STATE OF NORTH CAROLINA
DEPARTMENT OF TRANSPORTATION

Subject: Additional Information in Response to the N.C. Division of Water Quality's and USACE's Email Questions for the proposed new location facility from SR 2011 (Edgefield Road) to the Haw River at US 220 in Greensboro, Guilford County; Division 7; TIP No. R-2413 A & B; WBS Element No. 34429.1.1

Reference: 1) Application for Section 404 Individual Permit, Section 401 Individual Water Quality Certification, and Randleman Lake Buffer Authorization, May 14, 2013.
2) NCDWQ/USACE Emails, dated June 4, 11, and 13, 2013.

Permit Drawing
Sheet 13 of 31

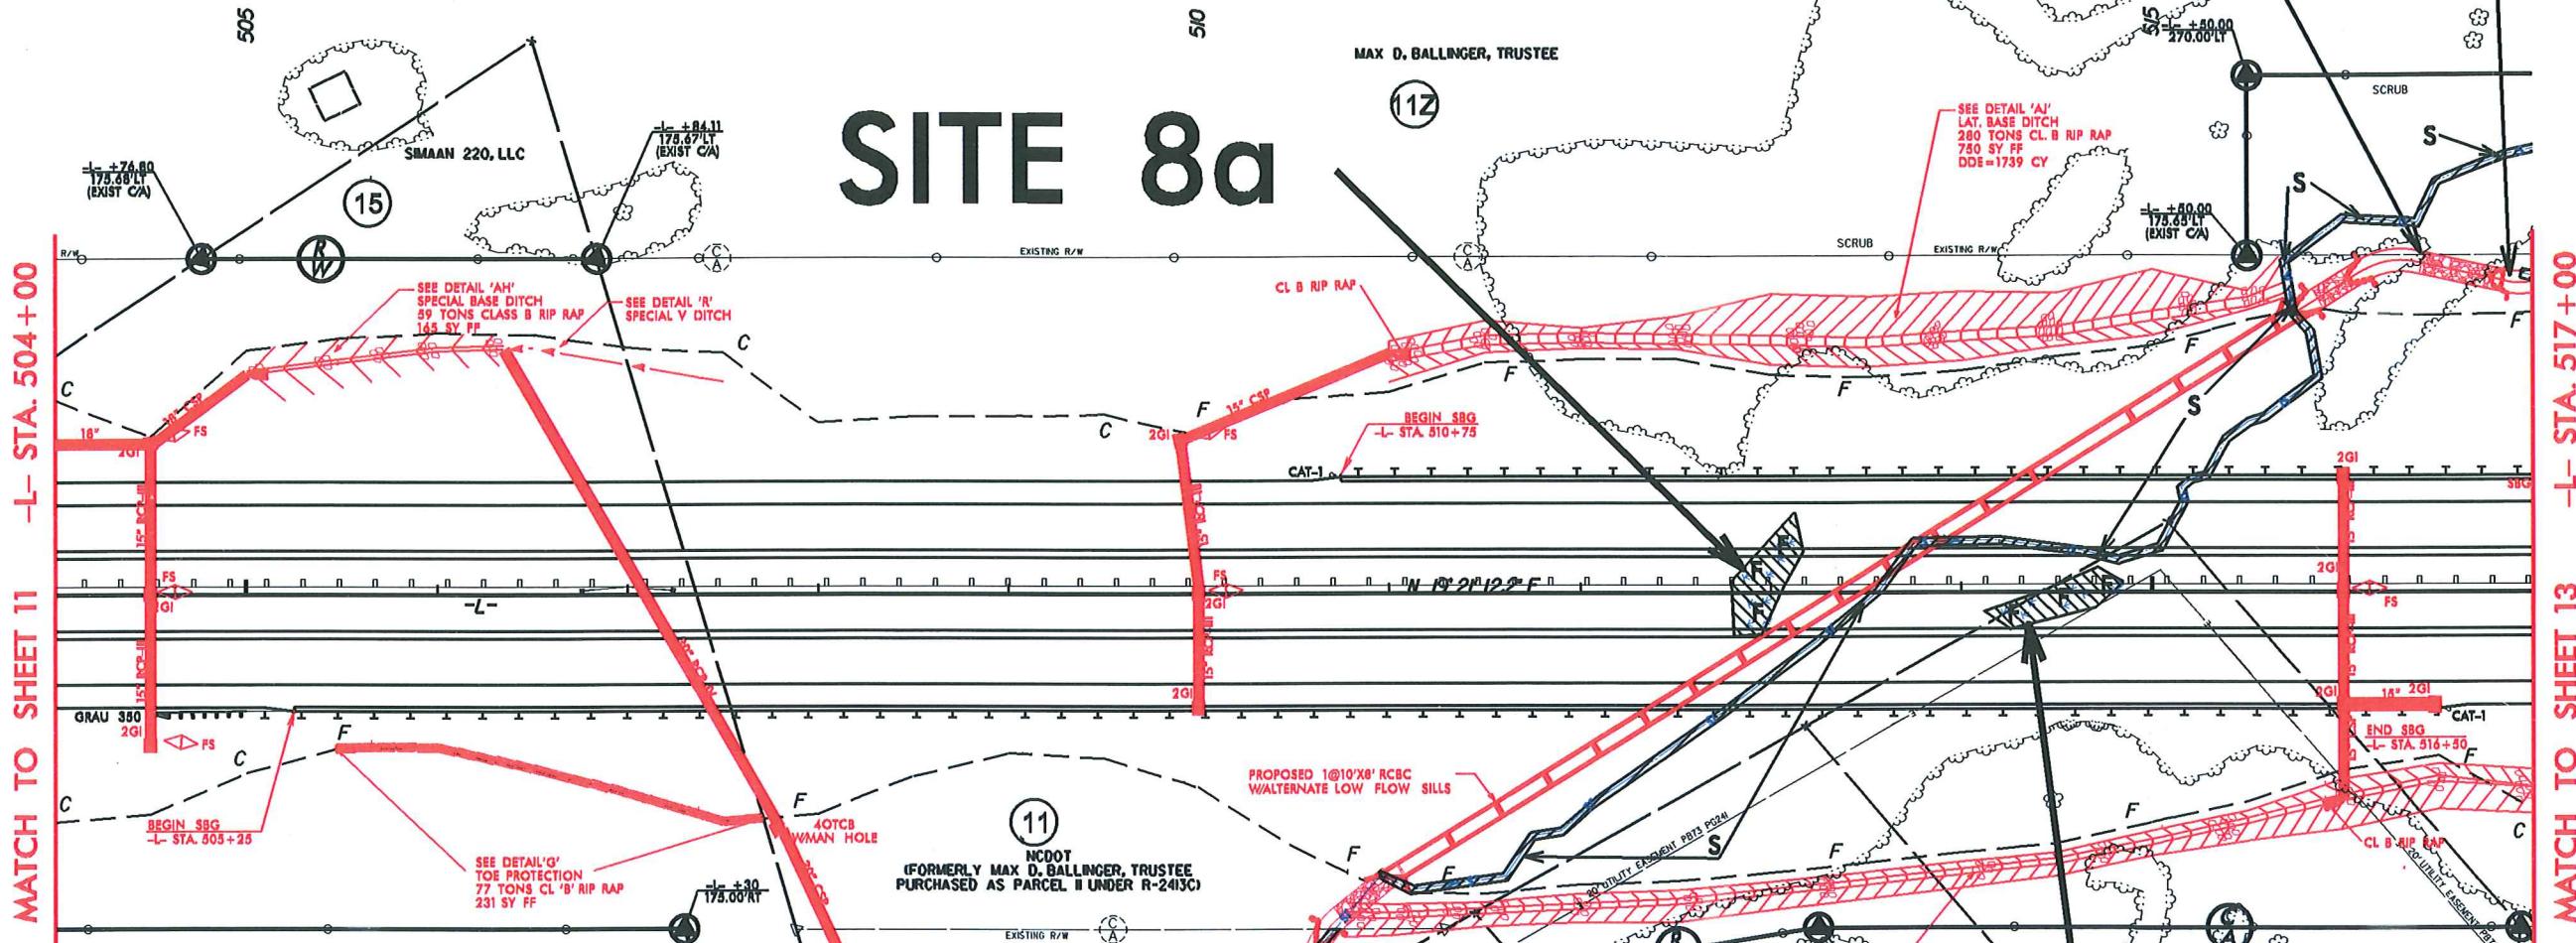
1) Permit site 8 (mitigation site 5) shows 2 ditches on the upstream portion that are not in the mitigation plans. Please update the plans, so they are the same. If the mitigation

site plans need to have the ditches added, include a statement that the mitigation design accounts for the stormwater input.

Mitigation plans have been updated to reflect the same information.

SITE 23

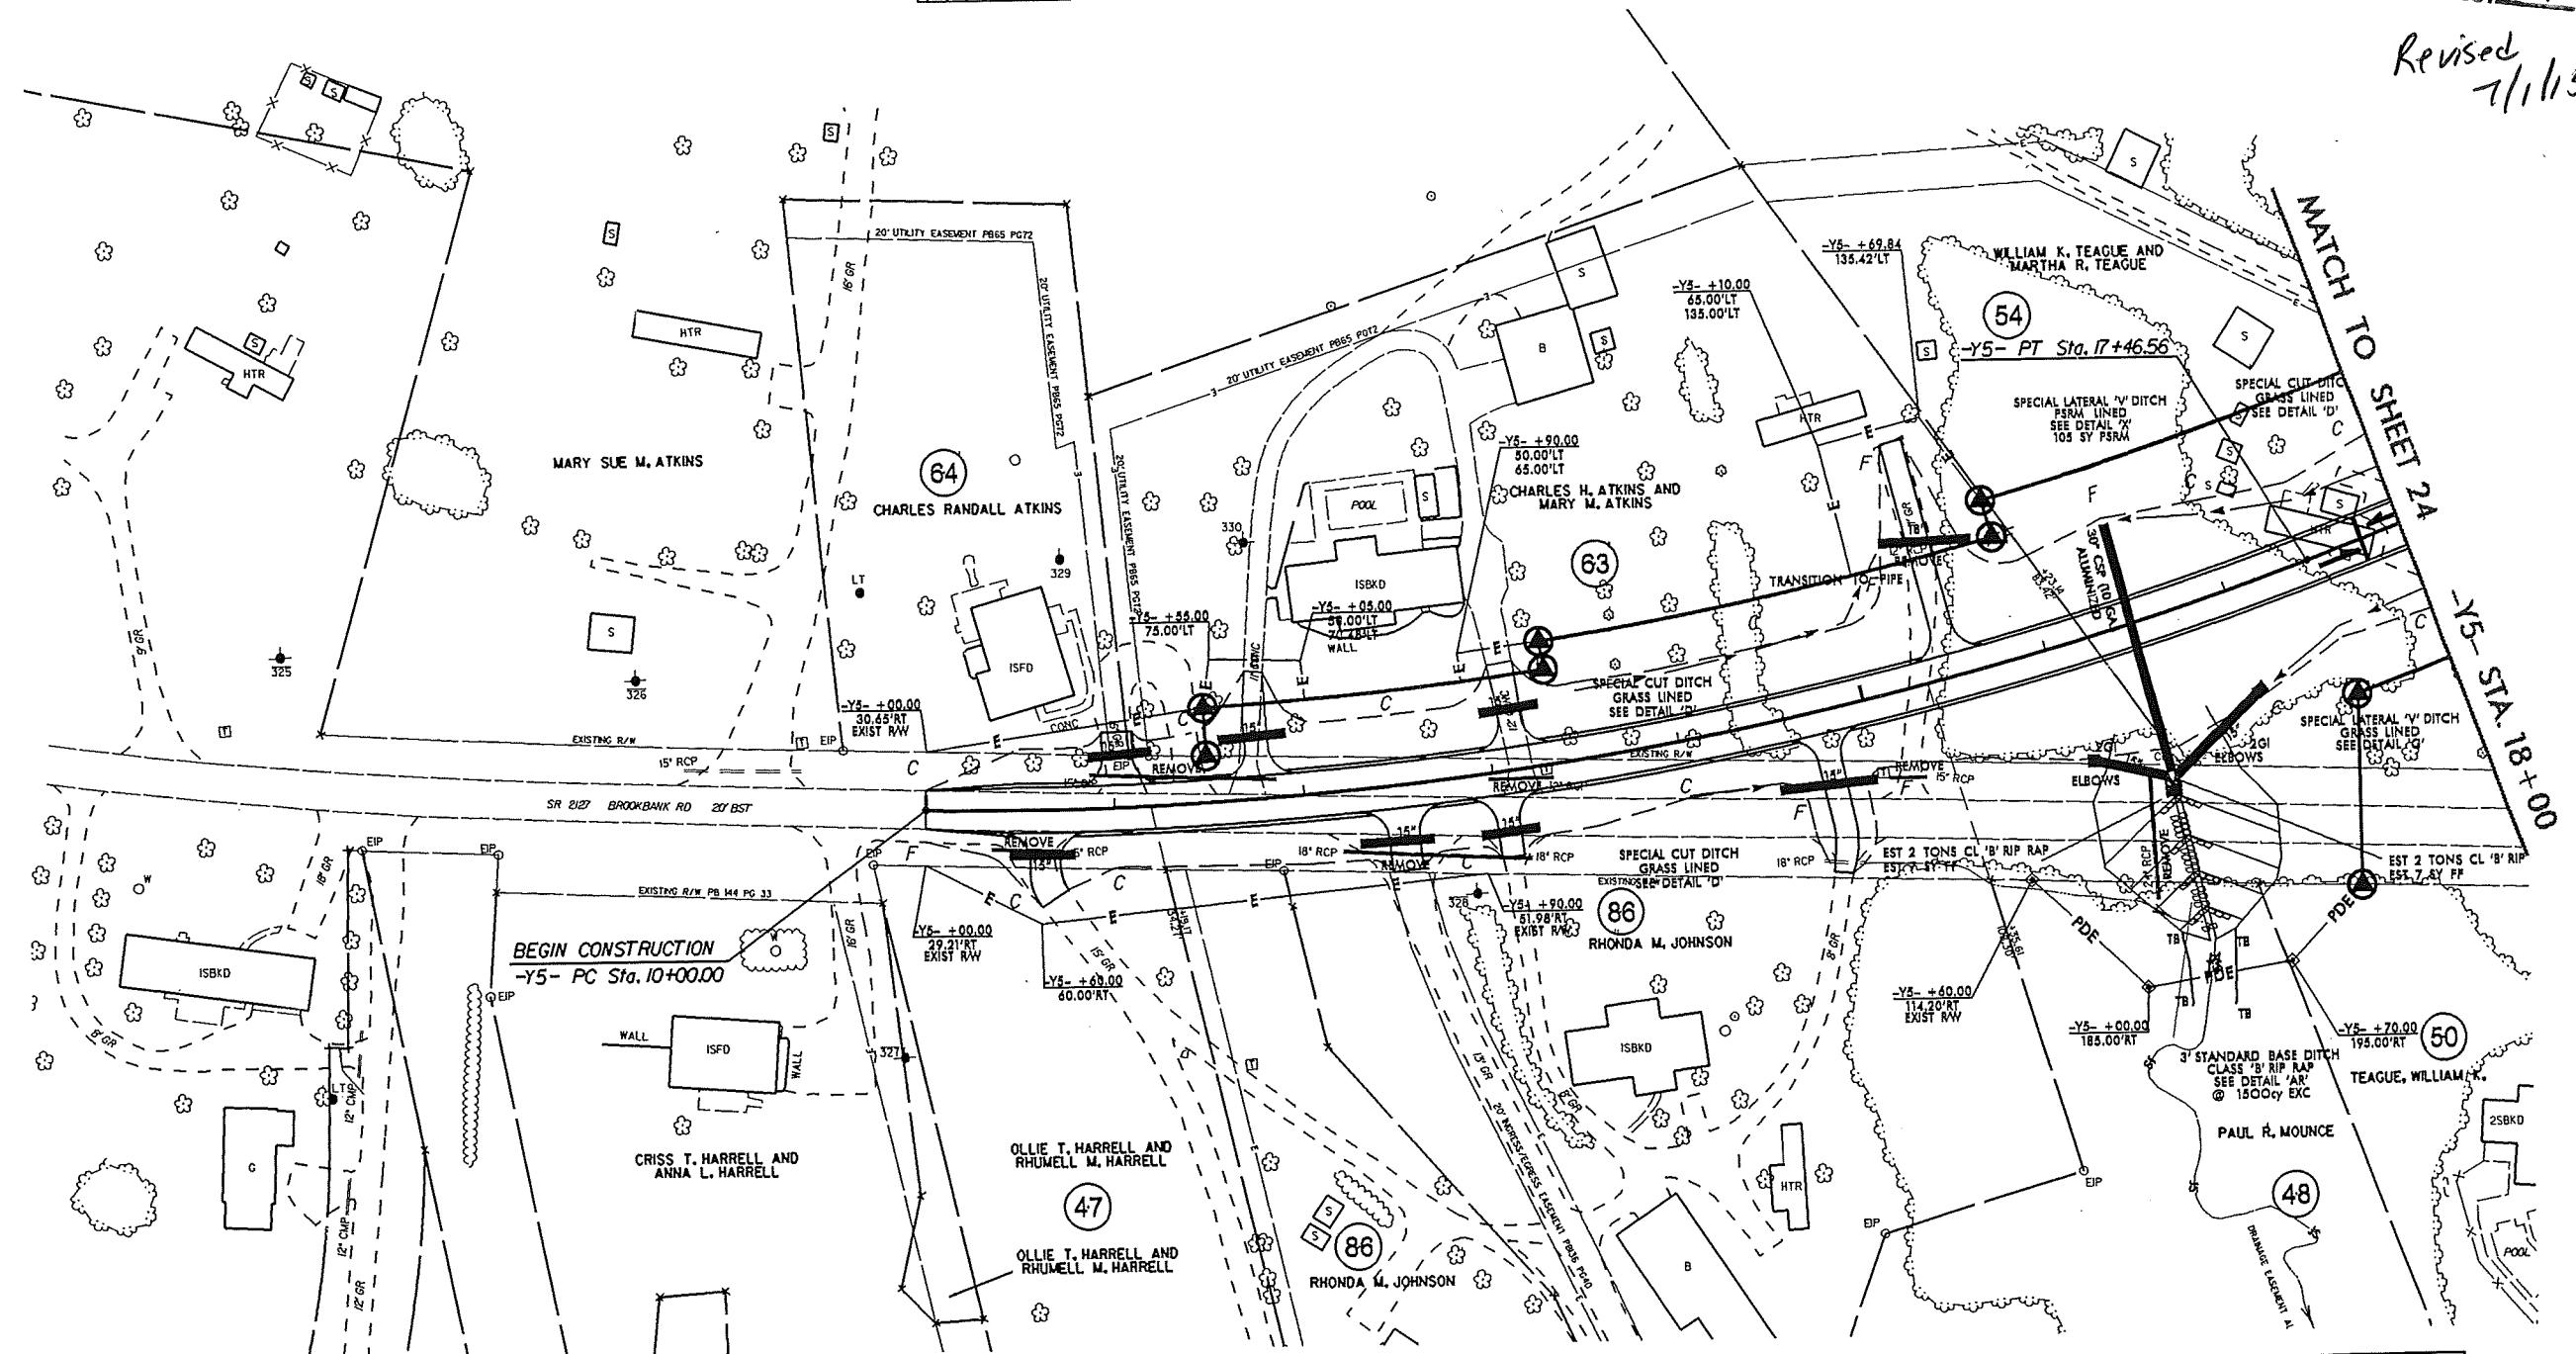
- 10) *Roadway plans sheet 33: At approximately sta no. 17+ 46, there is a PDE that's tied to a jurisdictional stream. Are there stream impacts associated with the PDE? If so, this should be a permit site.*

There are no direct impacts to the stream since the stream starts below the end of ditch and just above PDE line. There maybe temporary impacts with the construction in this area. A new site, Site 23, has been added to reflect these temporary impacts.
